RAPID CHECK 7001

Model: Fiat Ducato, all models

- rear axle fixing U-bolts

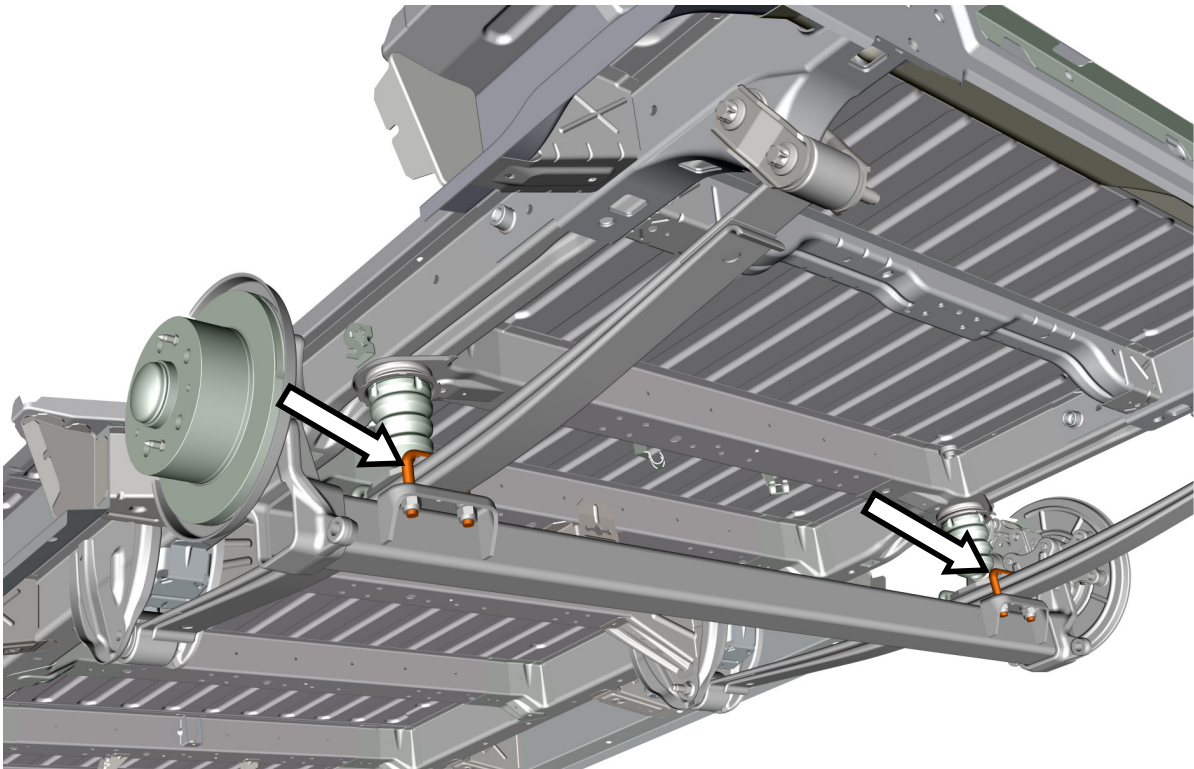
Working at the back of the vehicle, carry out the following operations:

- Identify the left and right U-bolts of the rear suspension.

- Restore the tightening of the nut for the U-bolts to the prescribed torque of **160 Nm**.
